# SERVICE BULLETIN ML 0011

Date : 13 September 1999  
Game : Slam'N'Jam (Serial < ML000870)  
Subject : DB Box Power Switch Connectors

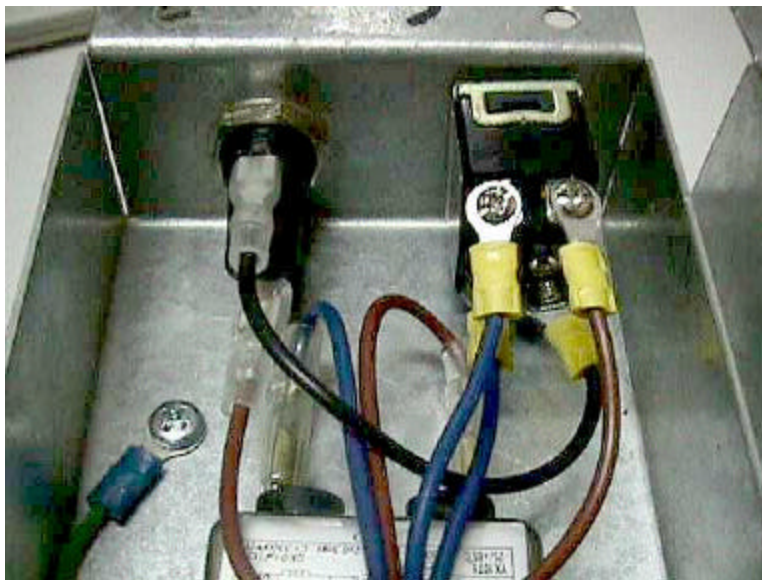
**Problem** : Loose Crimping and Screw Connectors on Power Switch inside Distribution Box (DB Box)

**Solution** : Open DB Box and check the four connectors on the Power Switch. Recommend soldering and heat shrinking of wire to Power Switch connector if Crimp is loose or Screw is unable to be tightened sufficiently
